DEVELOPMENT APPLICATION ASSESSMENT REPORT

Application Number:	DA2024/1617
----------------------------	-------------

Responsible Officer:	Michael French
Land to be developed (Address):	Lot 80 DP 14843, 92 Alfred Road NARRAWEENA NSW 2099
Proposed Development:	Alterations and additions to a dwelling house
Zoning:	Warringah LEP2011 - Land zoned R2 Low Density Residential
Development Permissible:	Yes
Existing Use Rights:	No
Consent Authority:	Northern Beaches Council
Land and Environment Court Action:	No
Applicant:	Olma Edlyn Fernandes

Figure 1: Envelope non-compliance (southern elevation)

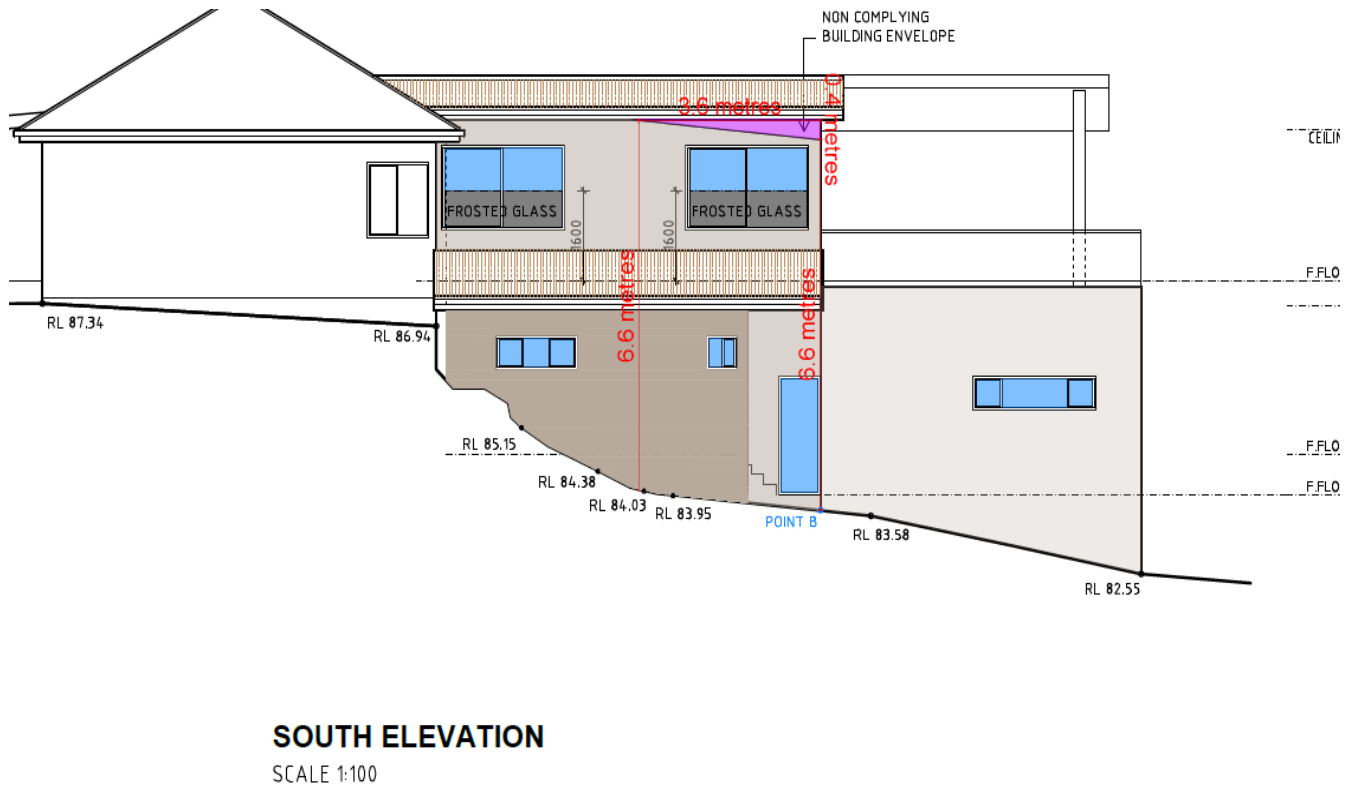
Clause B3 Side Boundary Envelope requires that built structures are sited within an envelope, measured at the side elevations of the dwelling by projecting planes at 45 degrees from a 4 metre height.

The proposed envelope non-compliance is considered minor and will not adversely affect the amenity of adjoining or surrounding sites, or unreasonably detract from the streetscape. Additionally, the proposed works wholly comply with the side setback requirements. In this instance a minor variation to *Clause B3 Side Boundary Envelope* is considered to be supportable as the outcomes of the control have been met as detailed below.

The proposed works will not unreasonably increase the height and bulk of the dwelling.

Adequate light, solar access and privacy is maintained to and from the subject site.

The development is considered to adequately respond to the topography of the site.
